**AGENDA**  
**Molalla Planning Commission**  
**6:30 PM, March 2, 2022**

- SDR07-2021 – 1000 W Main St (60-unit apartment complex)

The applicant/owner, Green Light -- Home First LLC is requesting approval of a Type III Site Design Review application for an apartment complex that will provide 60 affordable housing units. The subject property is located at 1000 W Main Street, contains approximately 2.95 acres, and is identified by the Clackamas County Assessor as Tax Lot 1500 of Tax Map 52E08C. As indicated by the attached Preliminary Development Plans, the applicant will remove an existing single-family dwelling, barn and accessory structures with the proposed development (see Exhibit 4).

6 TRASH ENCLOSURE  
 A202 3/16" = 1'-0"

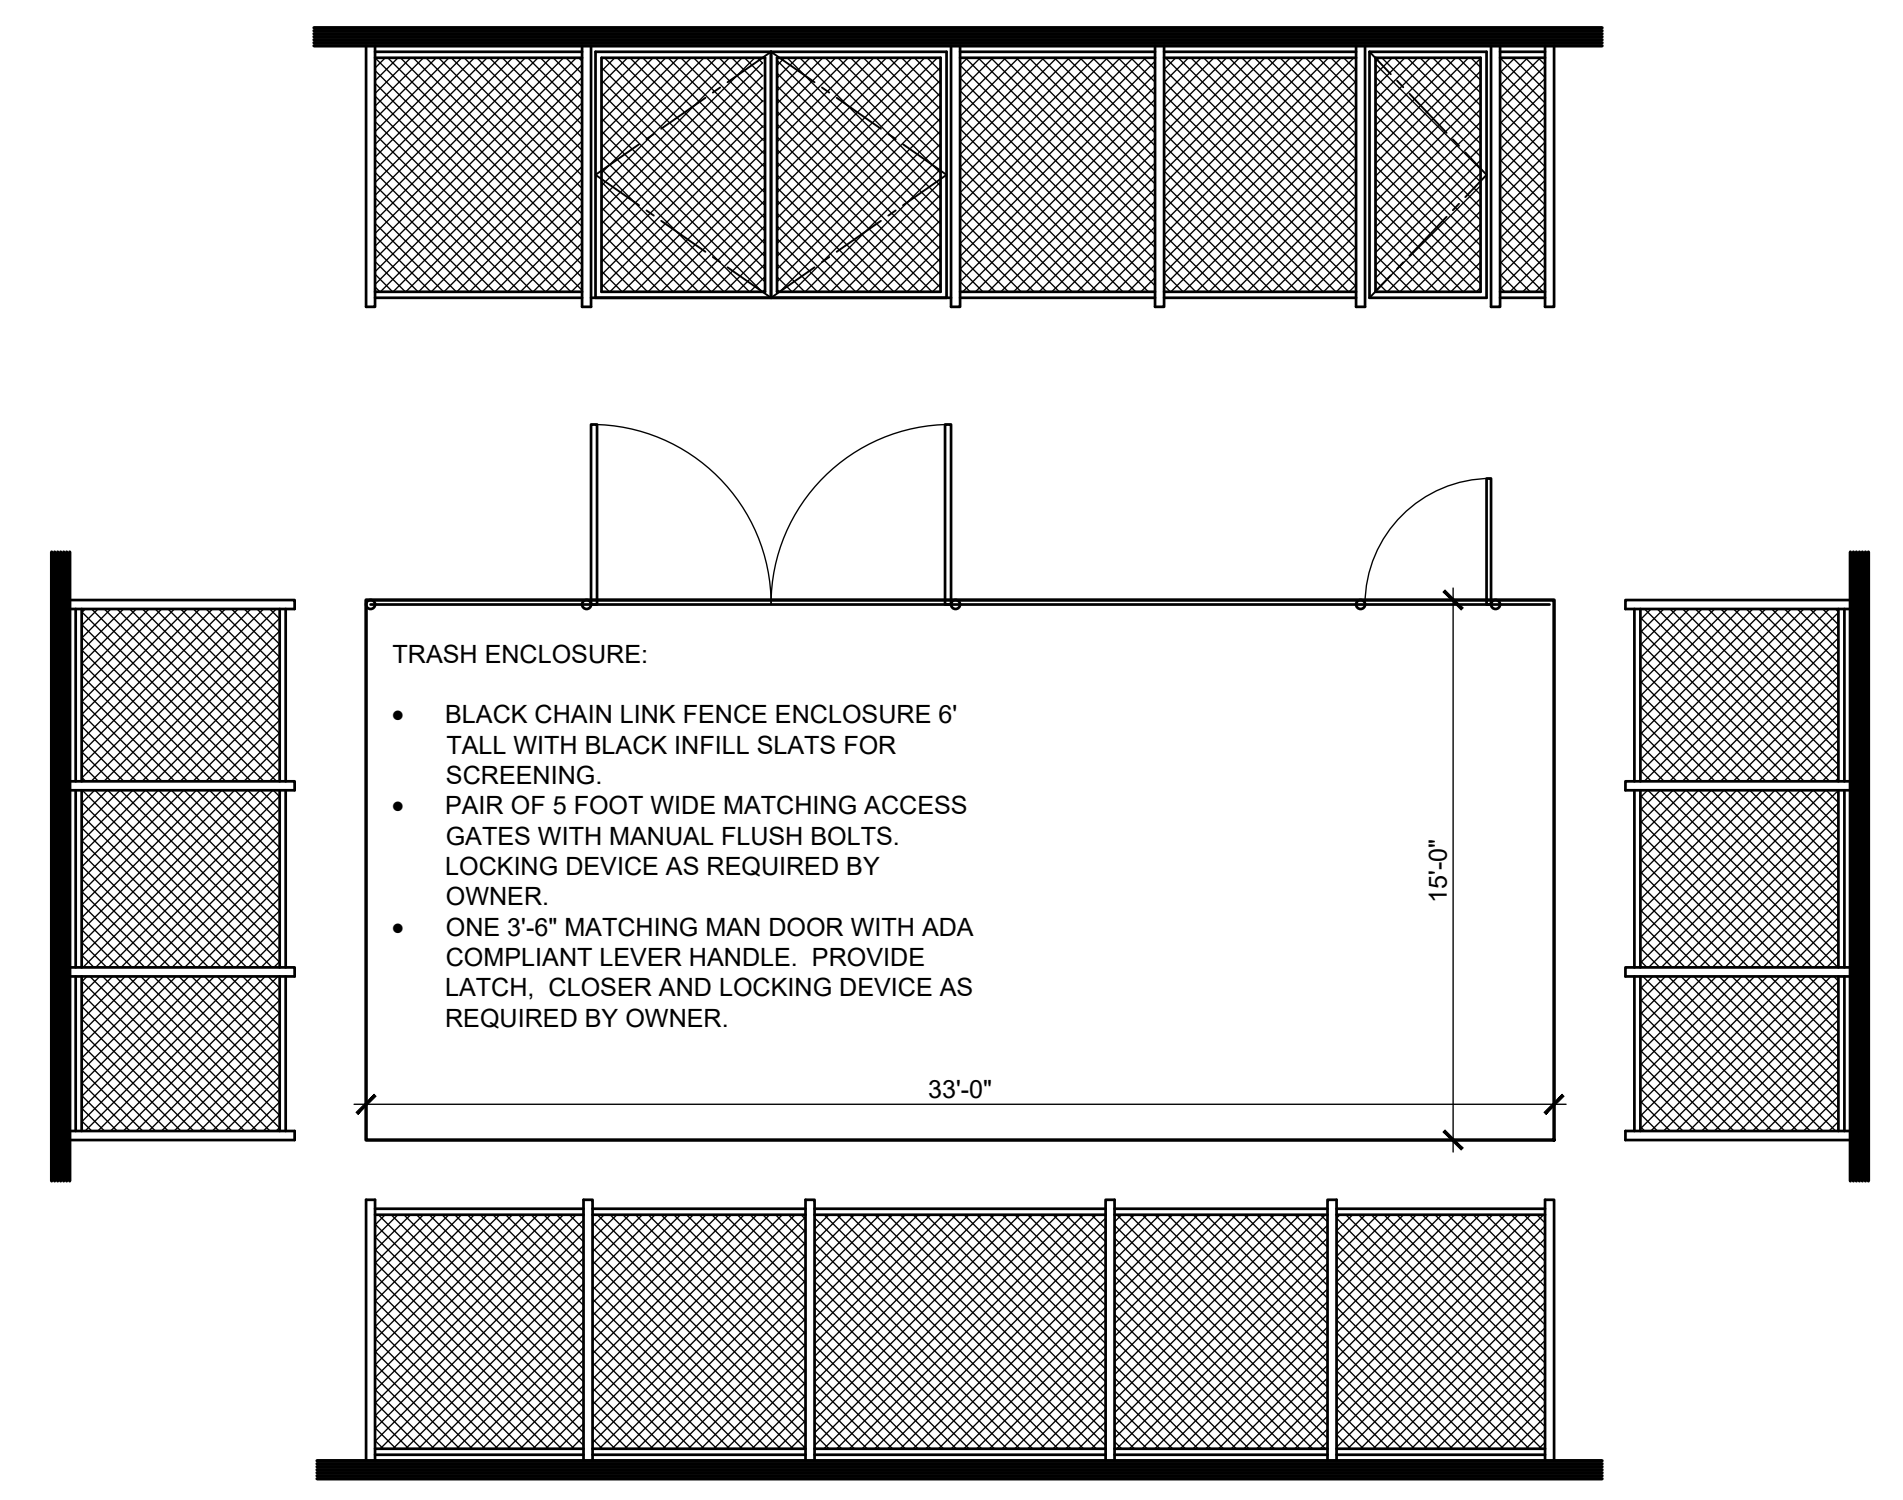
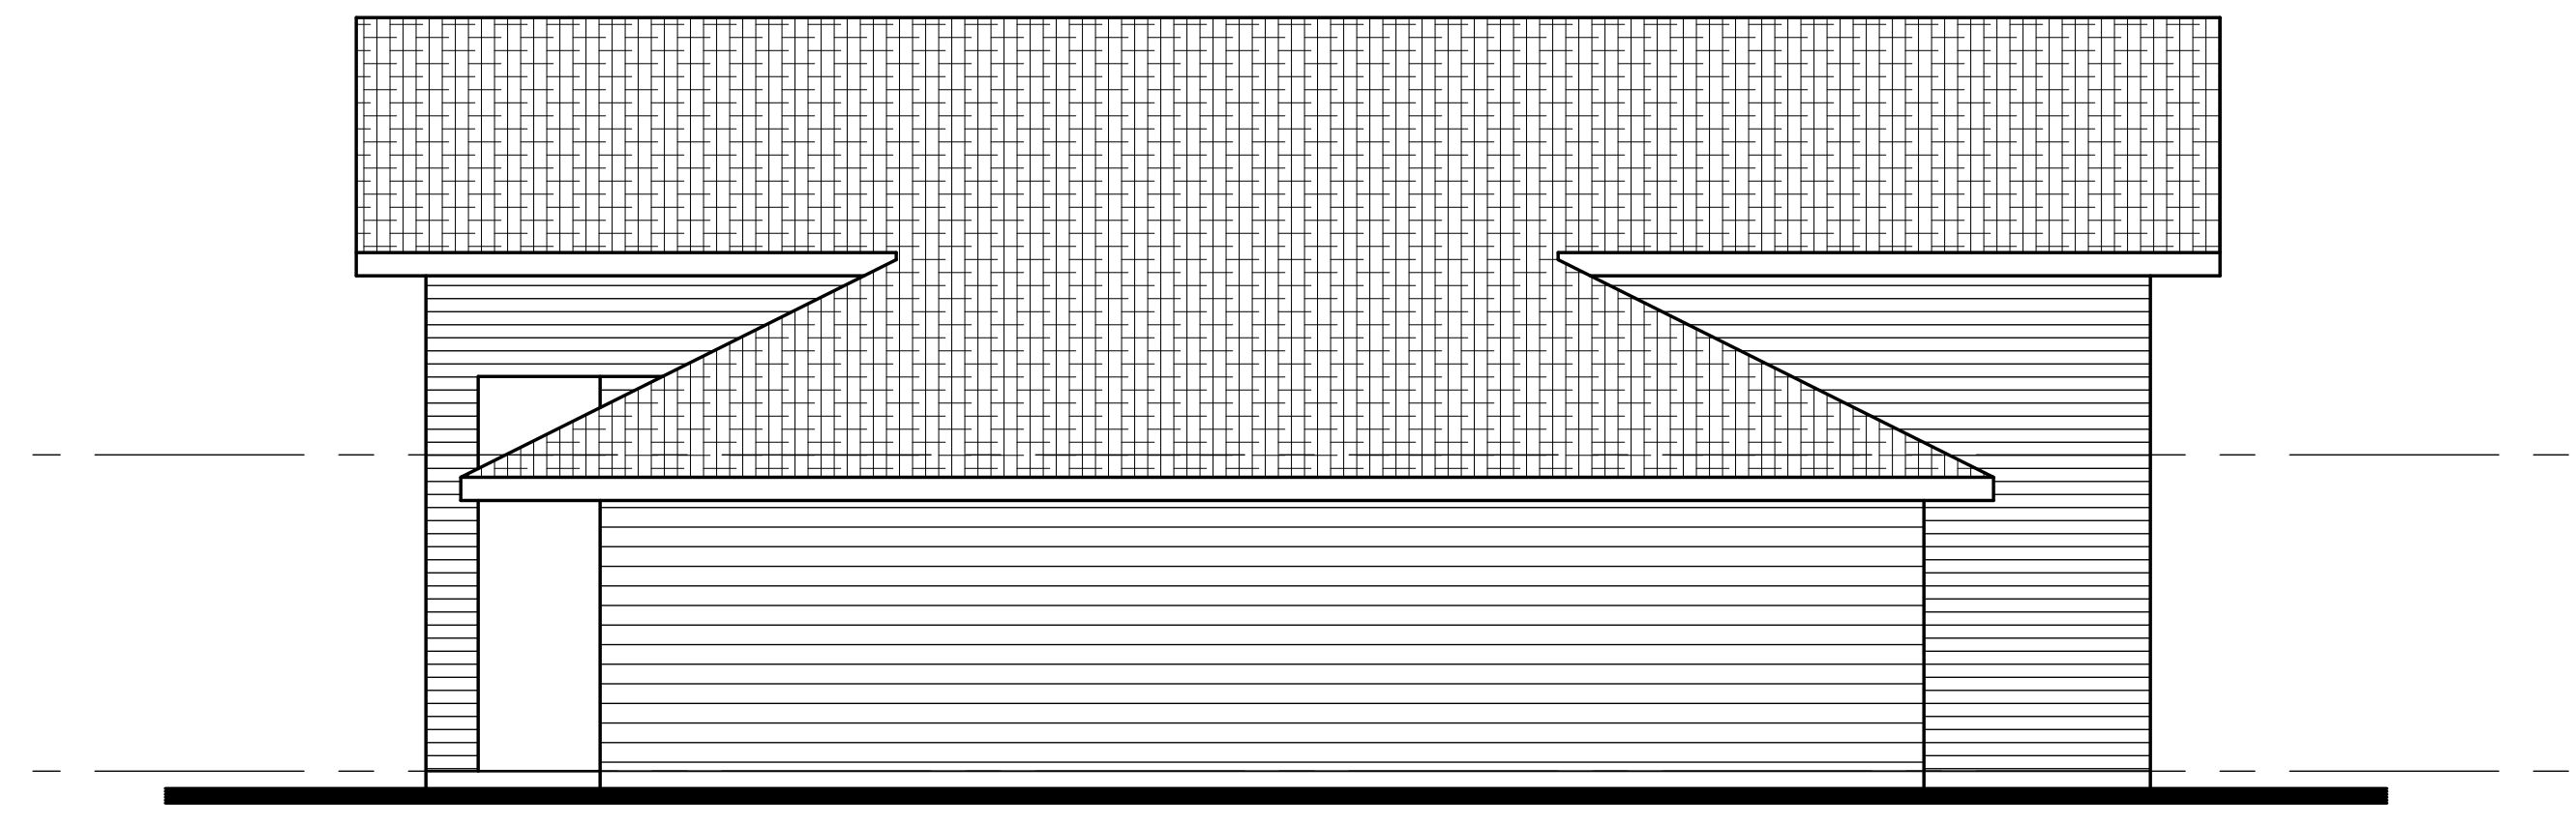
The attached Clubhouse and Trash Enclosure Plan indicates that the waste storage area will be screened by a 6-ft. high chain-link fence with slats (see Exhibit 4). Therefore, landscape screening is not required for the storage area.
